Jenkintown Borough Planning Commission approved meeting minutes for May 21, 2024

Re: MCPC #24-0086-001
Plan Name: Starbucks and Dessert Shop
(1 lot/3,522 sq. ft. commercial on approximately 7.9 acres)
Situates: Old York Road (E); south of Rodman Avenue
Jenkintown Borough

**RE: 610 Old York Road
Preliminary Land Development Plan Review (2nd Submission)
Borough of Jenkintown, PA**

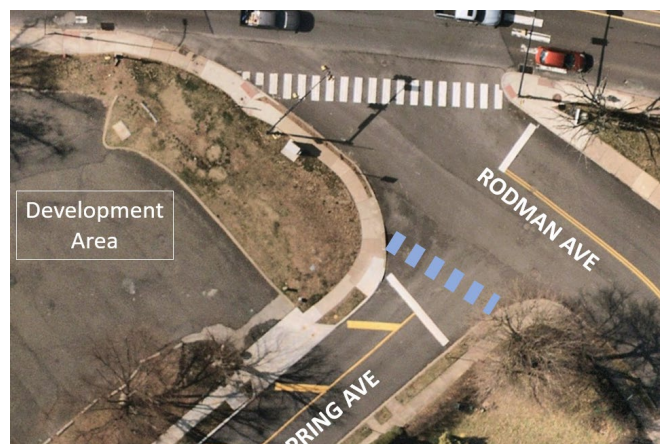
- F. Landscape Buffer. As noted on Sheet 13, a Class C buffer is required by §160-31.B. between the proposed commercial development and the existing residential area along Spring Avenue, and where the property abuts the side property line of a residential property on the west side of Spring Avenue. The required 10-foot buffer width should be dimensioned on the site plan and the appropriate amount of landscaping should be shown on the landscape plan.

Figure 5 of the borough’s subdivision and land development ordinance provides several options for a Class C buffer and a note on Figure 5 states that “a Class C buffer must be adequate to visually screen the proposed land use or development from off-site view” and that “grading treatments and architectural features; such as walls and/or fences may be required in addition to the minimum planting quantities in order to provide effective visual screening.” A fence is proposed in the vicinity of the pick-up window for the drive-through lane; however, the applicant may wish to consider whether additional berming and/or fencing could be incorporated to provide additional visual screening within the full buffer length.
